SERVICE BULLETIN

No. 515

Piper Aircraft Corporation

Control Cable Ball Joint Retainer Installation

TYPICAL BALL JOINT RETAINER INSTALLATION

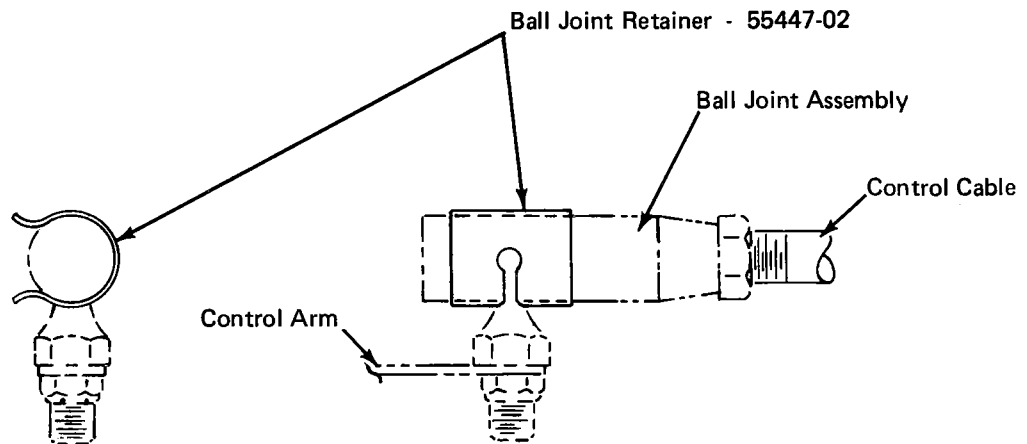
Purpose: There have been a few reports received from the field describing inadvertent detachment of the engine controls (i.e., throttle, prop governor and/or mixture) at the control cable ball joint attachment assembly. Failure of this ball joint assembly renders the particular control system inoperative. Although these ball joint attachment assemblies are subject to routine inspection, per published Piper inspection data, excessive wear - over a prolonged period of operation - in conjunction with inadequate inspection of this area - can permit detachment of the ball joint "ball" from its mating socket.

This service release announces availability of a safety device (retainer) that, when installed on the ball joint assembly, prevents disengagement of the ball from the socket (attached sketch/instruction sheet illustrates a typical ball joint assembly retainer installation).

1. Install ball joint retainer 55447-02, as shown above, to the control cable ball joint assemblies located in the engine compartment. See list below for appropriate model, control cable and quantity per airplane.

2. Install ball joint retainer 55447-02, as shown above, to the control cable ball joint assemblies located in the engine compartment and cockpit fuel control panel for the PA-31T. See list below for control cable and quantity.
